PROJECT BRIEF

Historic District Board of Review Application for Certificate of Appropriateness at 902 E. First St. to build a 24'x24' garage with 2 overhead doors, standard door, & window(s); materials to be finalized but will include either wood or cement siding.

HDCA-23-2

Certificate of Appropriateness (COA) Application

2-CAR GARAGE

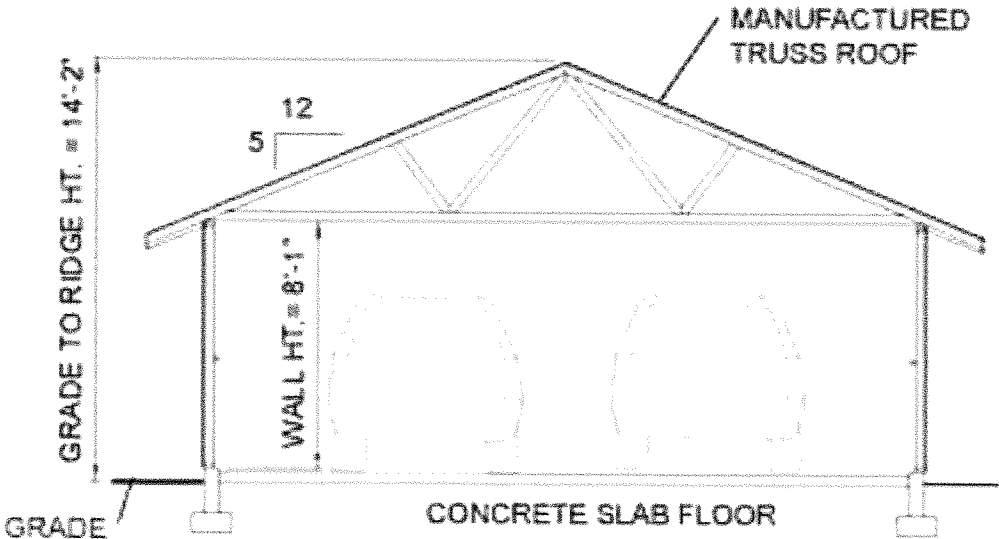
The project *is in* conformance with Guidelines 24.1-24.2 & 24.4-24.7 because the proposed garage will be located at the side/rear of the primary structure, the materials & design are compatible with both the surrounding neighborhood and the primary structure, & the height/massing/size is also compatible with the site and neighborhood; and *is in* conformance with the ordinance because the proposed garage is compatible in terms of visual factors.
